SUBJECT: INITIAL COMMENTS LETTER

PROJECT NAME: ON TOP OF THE WORLD ROAN HILLS AMENITY AREA

PROJECT #2021030089

APPLICATION: MAJOR SITE PLAN #26508

DEVELOPMENT REVIEW COMMITTEE WAIVER REQUEST FORM

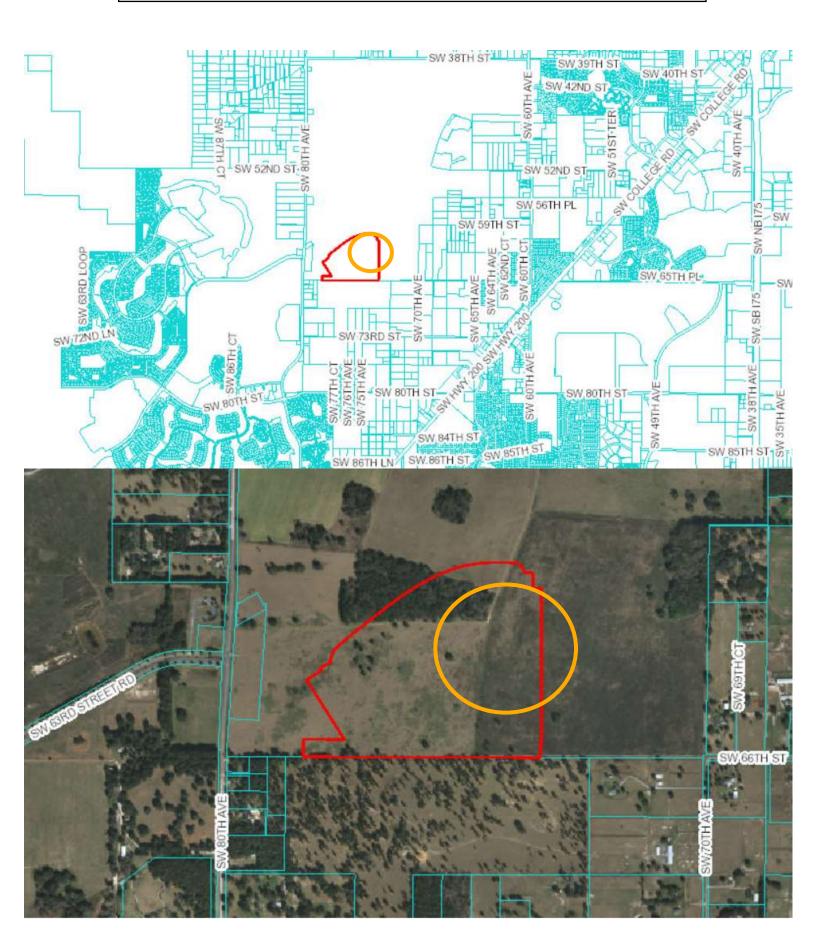
APPLICANT requests waiver for use of 12 inch and 15 inch RCP pipe. Stormwater conveyance calculations will be provided with the next submittal.
